CALL NO. 102
CONTRACT ID NO. 121001
ADDENDUM # 2

Subject: Pike County, APD 0806 (040)
Letting January 27, 2012

- (1) Revised - Plan Sheets - T1, T56, T57, & T58
- (2) Revised - Bid Items - Pages 84-88 of 88

1 REVISED 01-11-2012

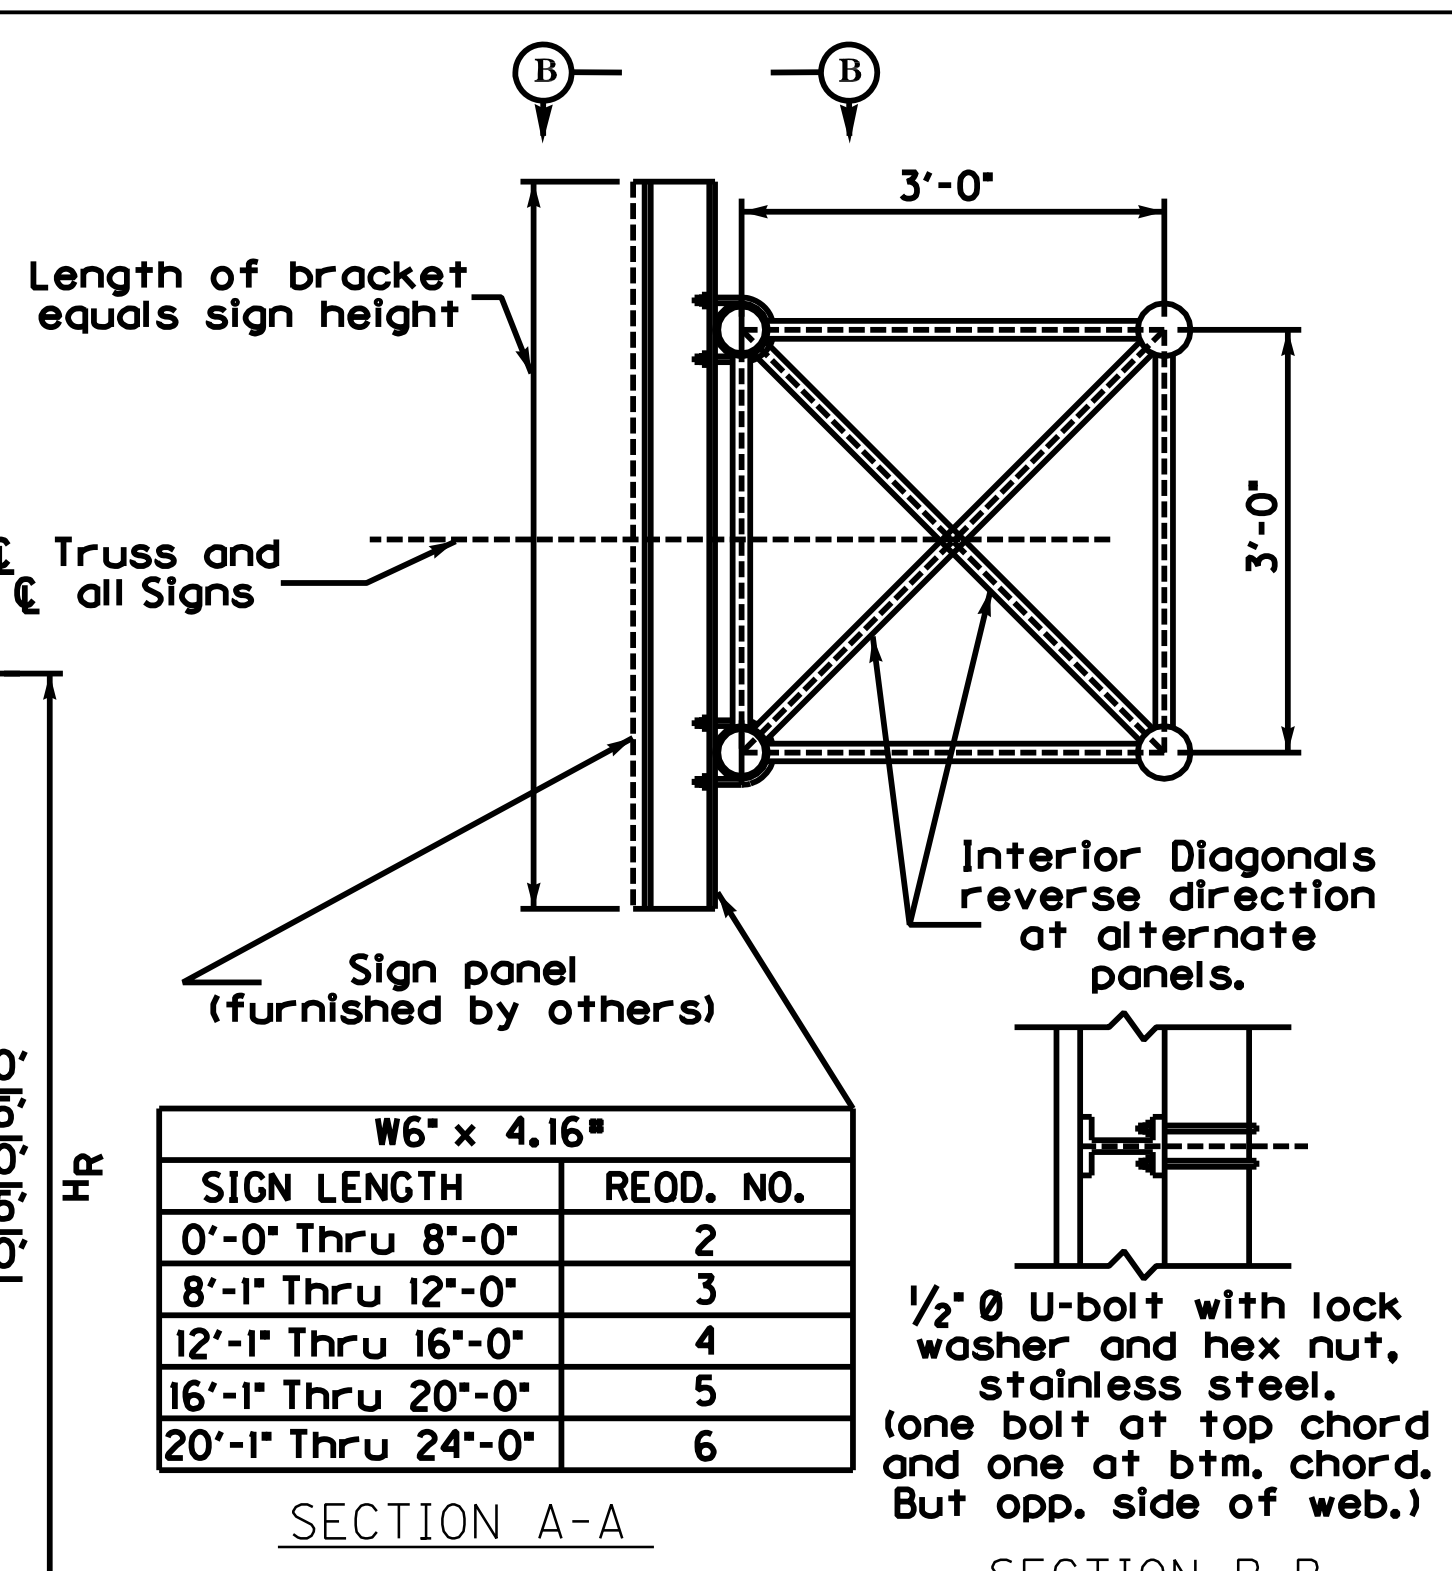
STA. 1+160
NOTE: SIGN TRUSS FOUNDATION DATA (UP TO BASE PLATE) FOR INFORMATION ONLY. SUPERSTRUCTURE TO BE CONSTRUCTED UNDER THIS PROJECT.

1 MODIFIED NOTE

PREPARED BY: Division of Structural Design SHEET NO. T058
DRAWING NO. _____

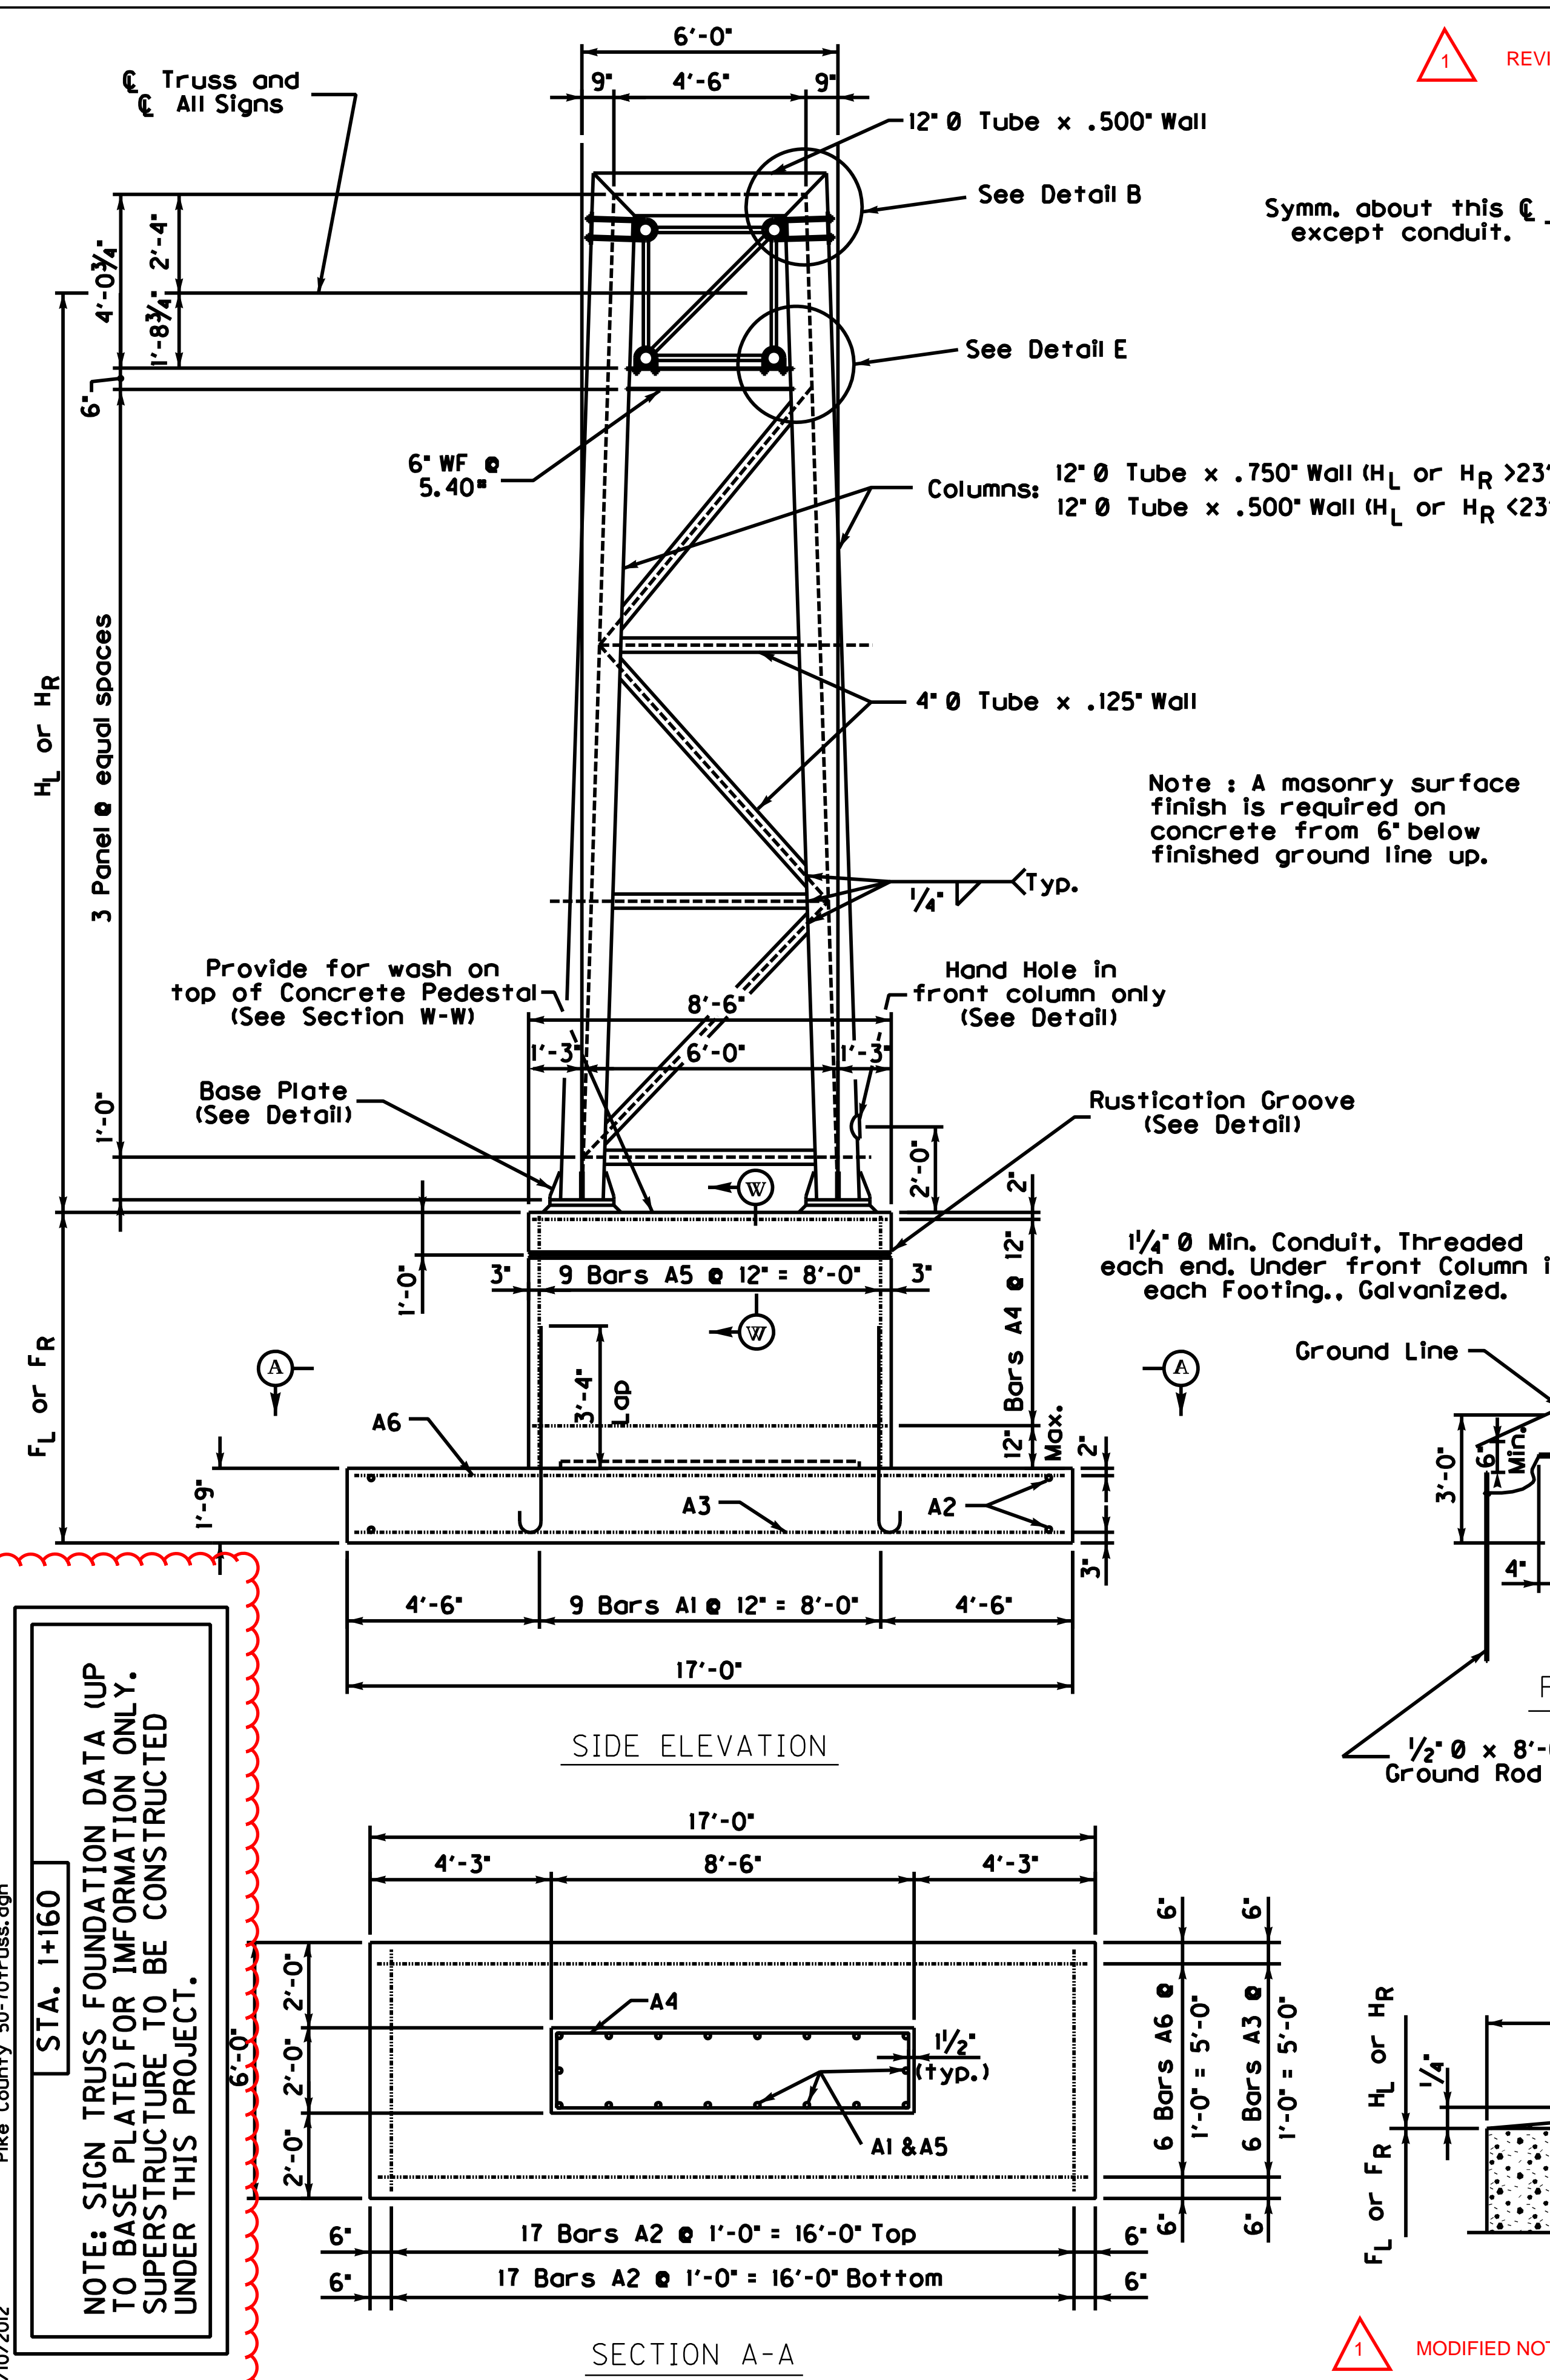
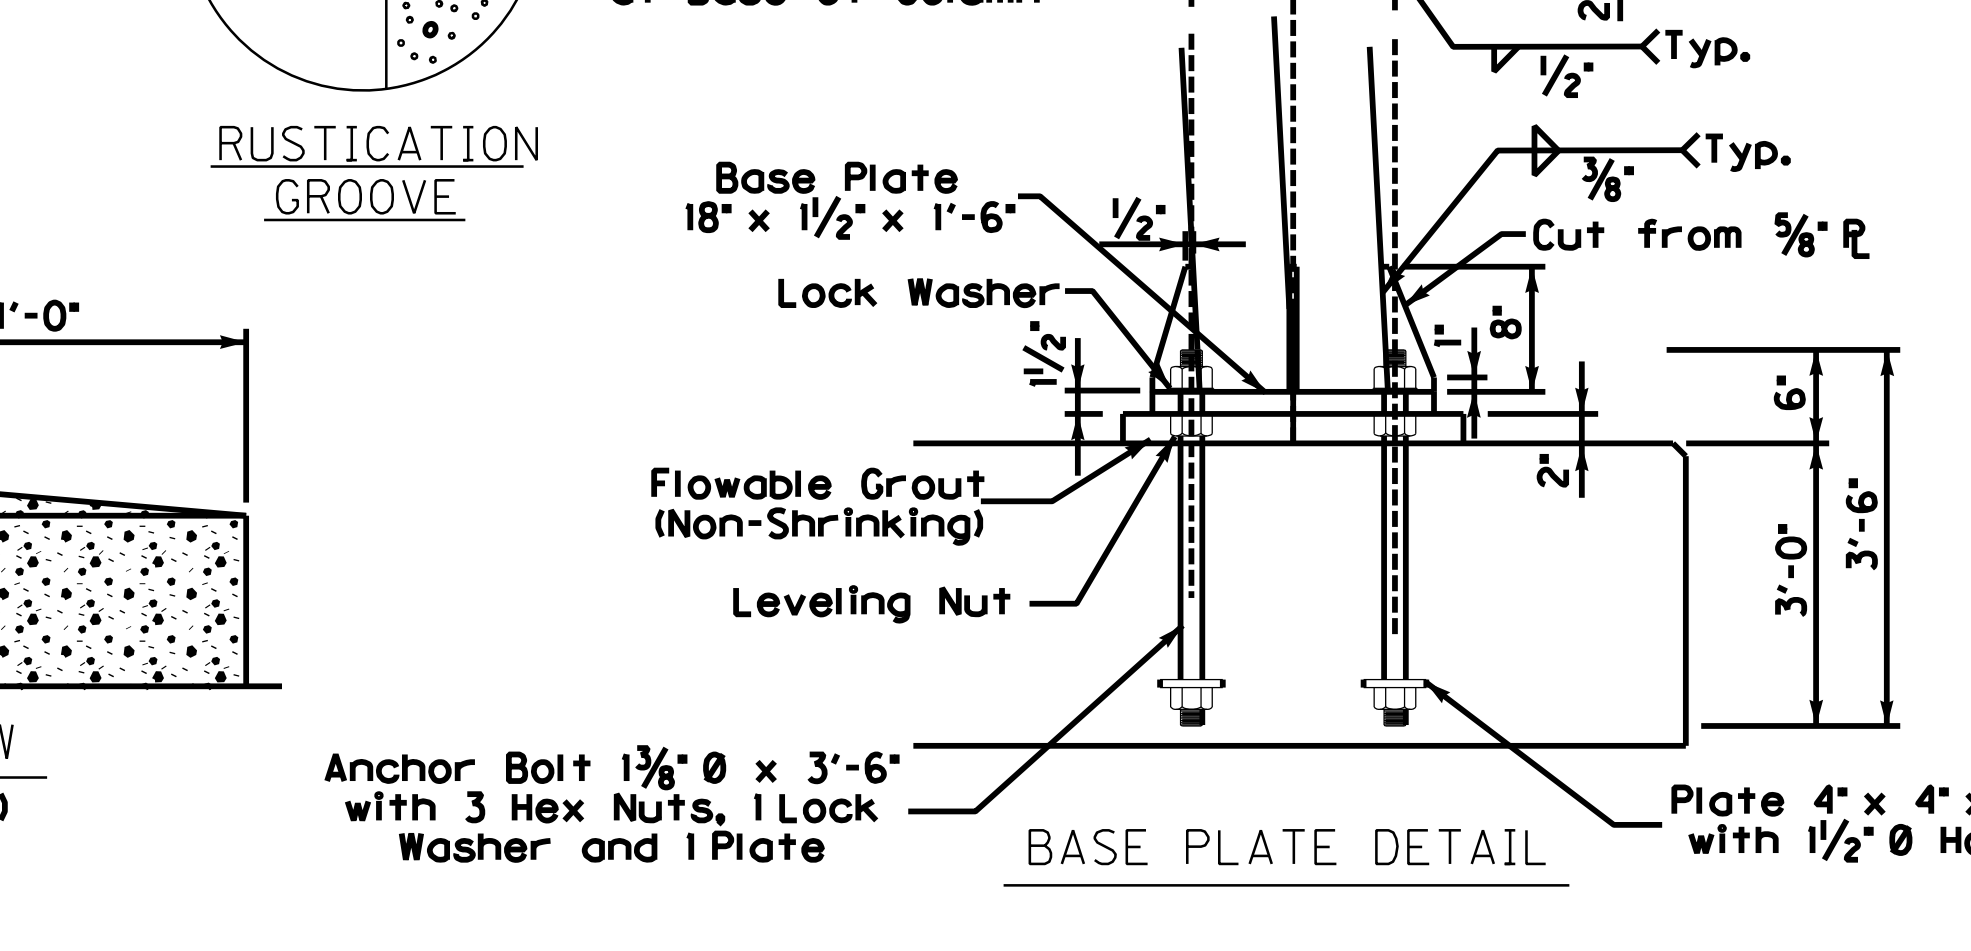
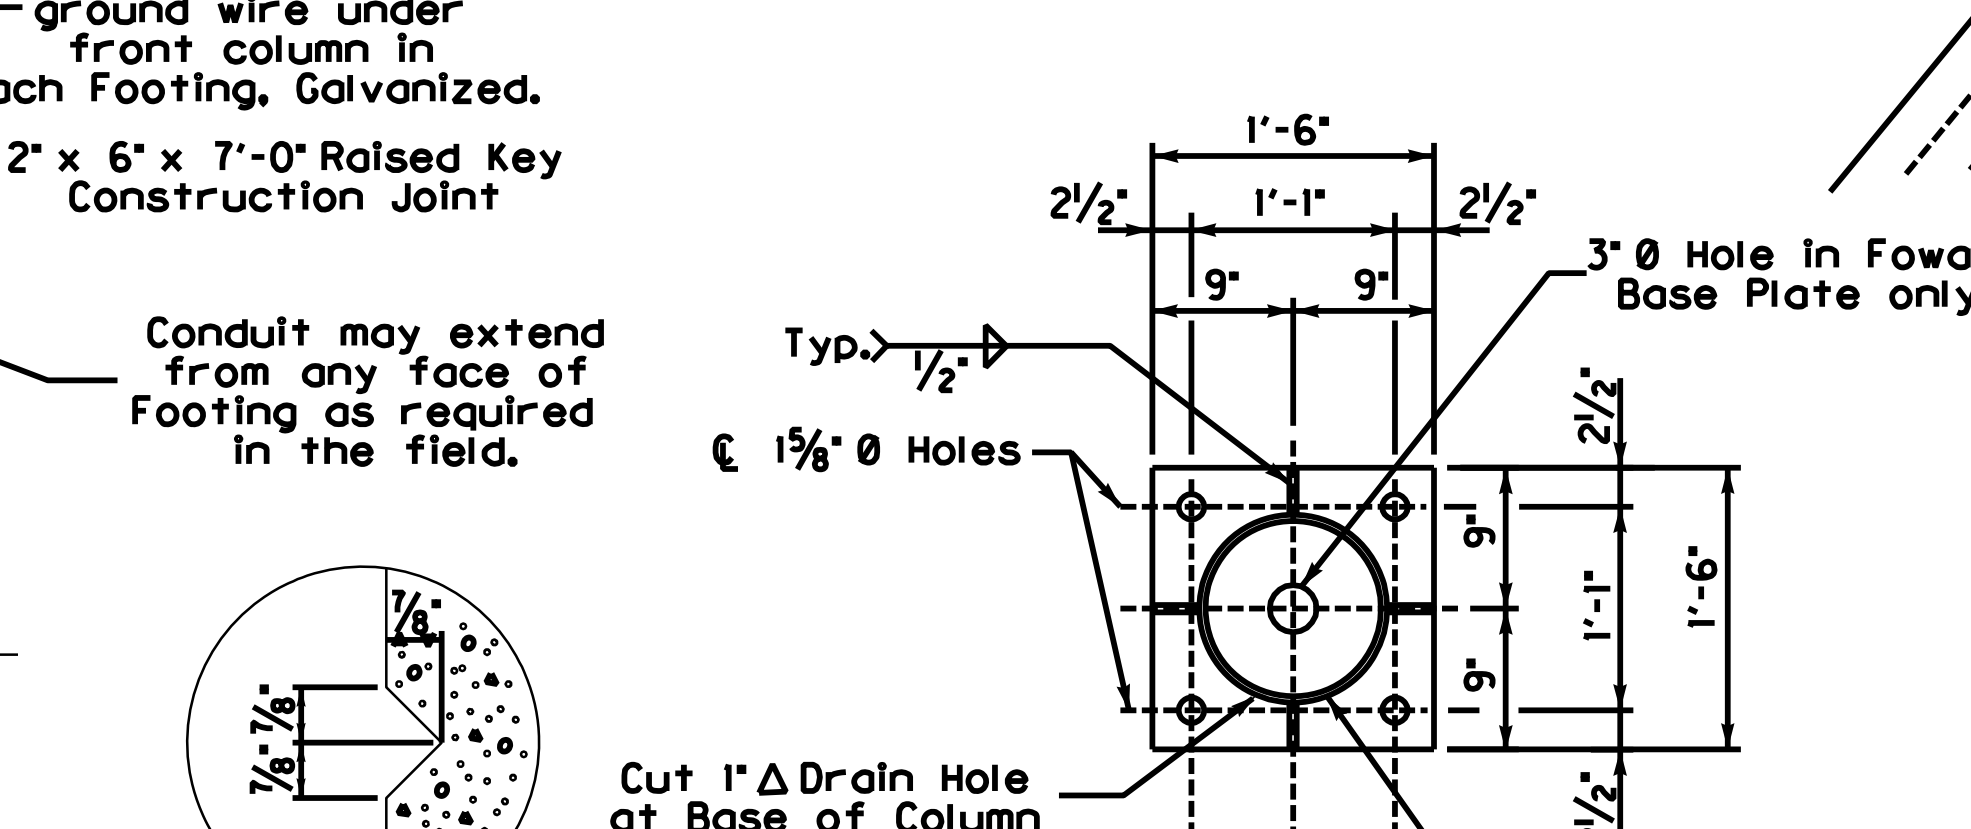
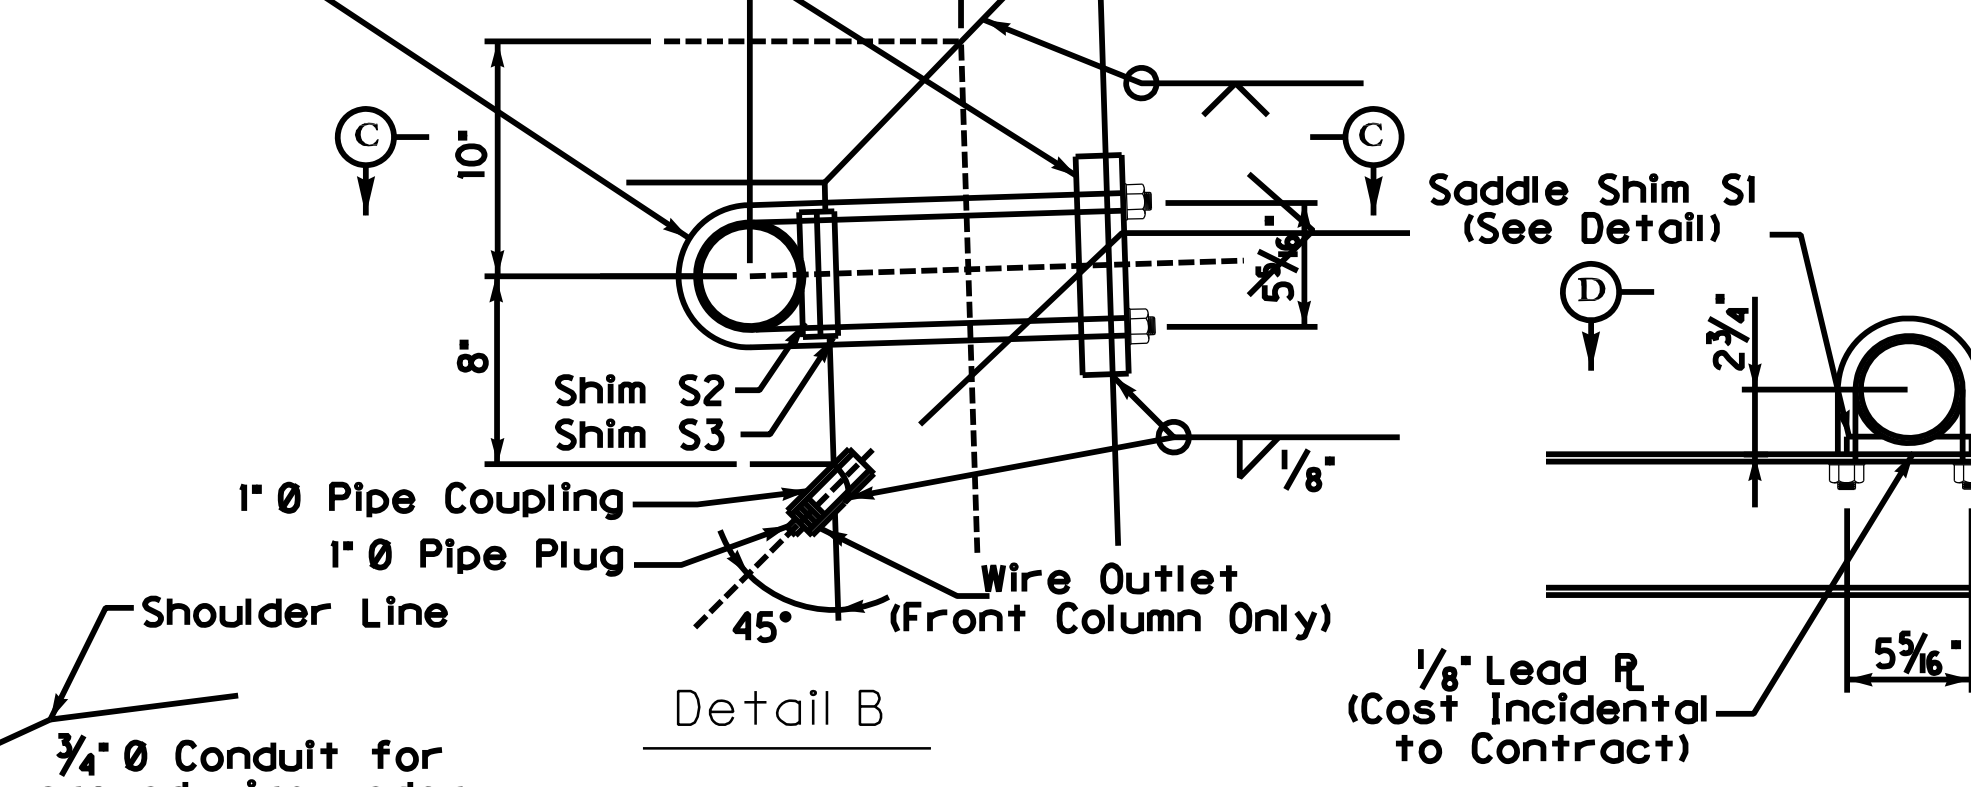
1 MODIFIED NOTE

NOTE: SIGN TRUSS FOUNDATION DATA (UP TO BASE PLATE) FOR INFORMATION ONLY. SUPERSTRUCTURE TO BE CONSTRUCTED UNDER THIS PROJECT.
